Access Compliance Report

Public Rights-of-Way

Intersection ID: 23663	Main Street: S_TRYON_ST	Cross Street: ERWIN_RD	Location: NW
ADA ID: 3FD9CFB2A0FC	Ramp Type: Perp	Initial Pass/Fail: Fail	Overall Compliance: No
Severity Score: 22.5			
Codes/Mitigation Info/Possible Solution		Field Measurements/Component Compliance

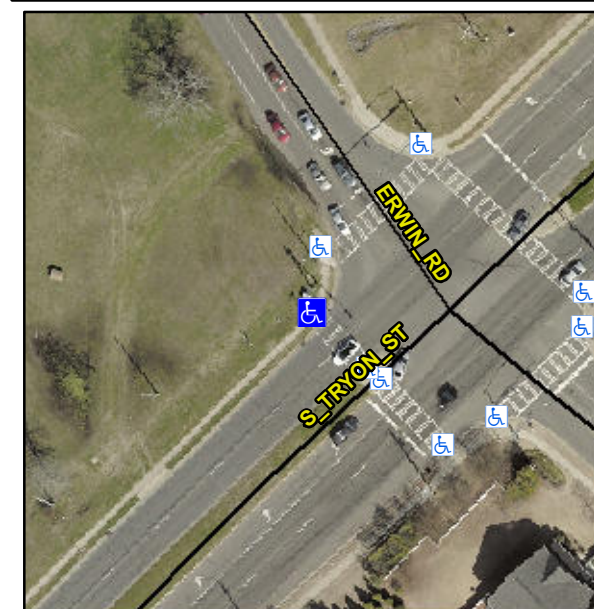
Not Found, R304.5.1, R304.2.2, R304.5.3

Compliance	Description	Data	Compliance	Description	Data
N/A	Ramp Length (in)	48.0	No	Ramp Slope (%)	8.6
No	Ramp Width (in)	46.0	No	Ramp XSlope (%)	2.3
N/A	Flare Type LT	N/A	N/A	Flare Type RT	N/A
N/A	Flare Slope LT (%)	N/A	N/A	Flare Slope RT (%)	N/A
N/A	Flare Traversable LT?	N/A	N/A	Flare Traversable RT?	N/A
N/A	Landing Length (in)	N/A	N/A	DWS Provided?	N/A
N/A	Landing Width (in)	N/A	N/A	DWS Contrast?	N/A
N/A	Landing Slope (%)	N/A	N/A	DWS Length (in)	N/A
N/A	Landing X Slope (%)	N/A	N/A	DWS Full Width?	N/A
N/A	Landing Curb? (Y/N)	N/A	N/A	DWS Offset (in)	N/A
N/A	Shared Landing?	N/A			
N/A	Gutter Ponding?	N/A	N/A	Gutter Slope (%)	N/A
N/A	Gutter Lip Ht (in)	N/A	N/A	Gutter X Slope (%)	N/A
N/A	Painted X Walk1?	Yes	N/A	Painted X Walk2?	N/A
	X Walk 1 Direction	To SE		X Walk 2 Direction	N/A
N/A	X Walk 1 Width (in)	115.0	N/A	X Walk 2 Width (in)	N/A
	X Walk 1 Slope (%)	2.0		X Walk 2 Slope (%)	N/A
	X Walk 1 X Slope (%)	0.4		X Walk 2 X Slope (%)	N/A

Remove & Replace Entire Ramp.
